FILE NAME: N39430-15-D-1632 TO-0005 Sub 107.1 T14 OOS Inspection Report

CONTRACT NO	TITLE Fill in Project Title/Location Here
N39430-15-D-1632 / TO #0005	Clean, Inspect, Repair POL Storage Tanks 14 17 & 18 Red Hill, Pearl Harbor, HI

ENCL. NO.	NO. OF COPIES	DESCRIPTION	SPEC. SEC.PARA./DWG.NO.	SCHEDULE ACTIVITY NO.	CQC CODE
1	1	Tank 14 Out of Scope Pre-Repair Inspection Report	01 33 10.05 20/3.1	CI0701-080

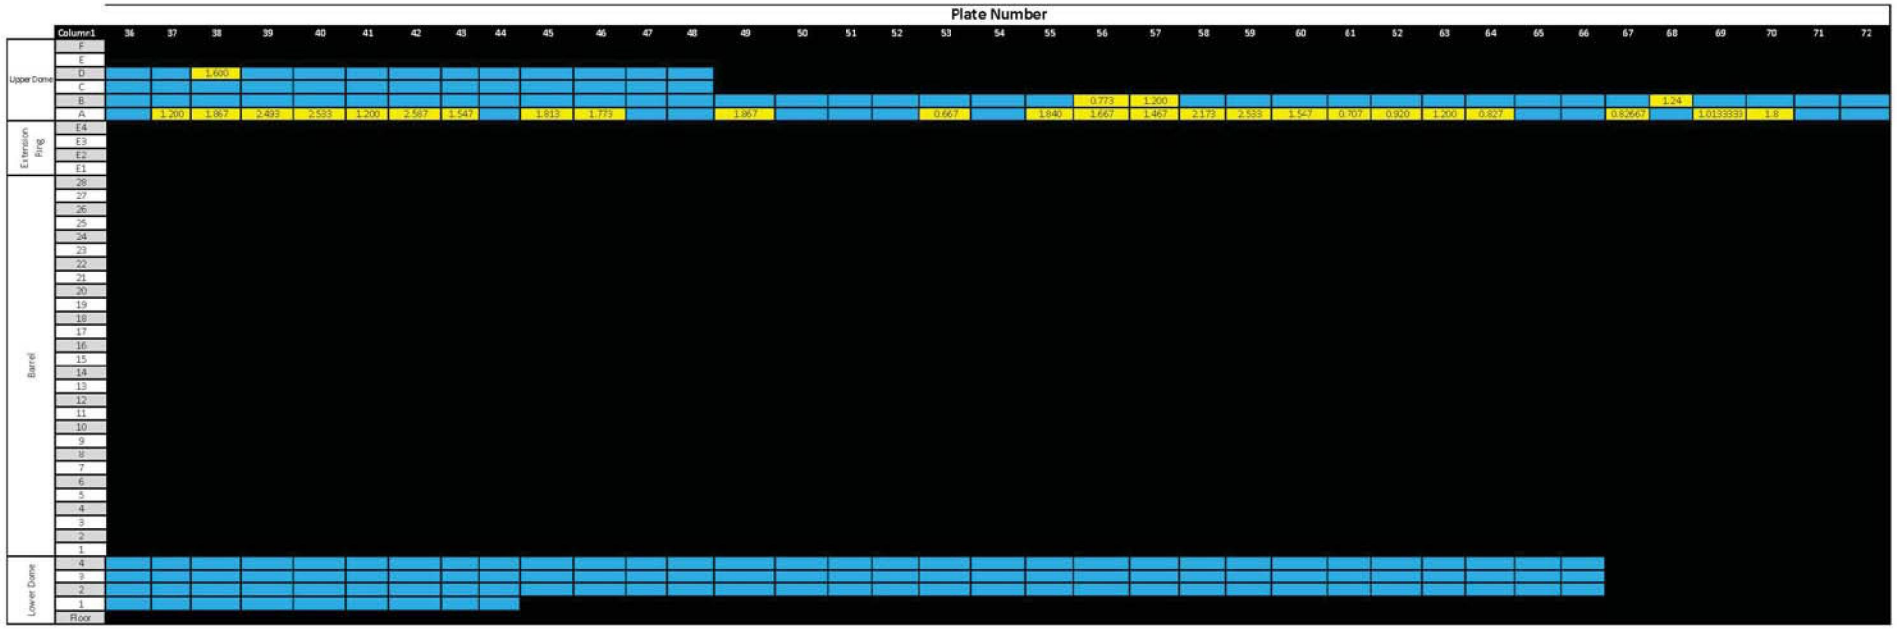
9.	Attachment G, Corrosion rates by plate	States the data are for Tank 17, both sheets. Verify the correct graphics are in the report.	Changed tank 17 to 14 on tank roll out. Verified data was for tank 14
